Certificate of Appropriateness Decision	CITY USE ONLY Case Number: PLCOA20220168 DRHPB Meeting Date: May 04, 2023
NAME OF PROJECT: Harris Building Revision	
PROJECT DESCRIPTION: Proposed change to one new exterior door of the "Harris Building," a property listed on the local historic register, which received COA approval January 19, 2023.

Certificate of Appropriateness
Determination
Harris building revisions

NORTH ELEVATION

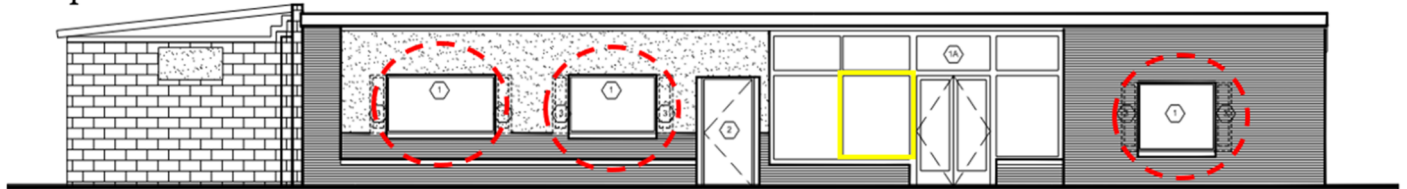
- a. **North Elevation:** the three proposed window replacements for existing exterior windows on the north building façade, as shown on the proposed building elevation drawings (also captured below and called out with red dashed circles), is what the Board approved in this determination (i.e. picture windows). In addition, one panel of the existing storefront window is also approved to be replaced “like for like” (subject window panel denoted below with a yellow outline).

WEST ELEVATION
SCALE: 1/4" = 1'-0"

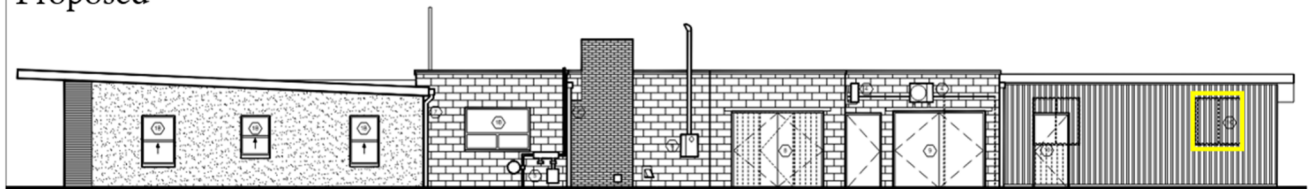
- b. **West Elevation:** the existing south window on the old horse stall (highlighted in yellow) on the elevation drawing below was shown on the elevation drawings to be eliminated; however, the applicant clarified at the meeting that it was not intended to be eliminated but replaced with a single-hung window, which was approved by the Board.
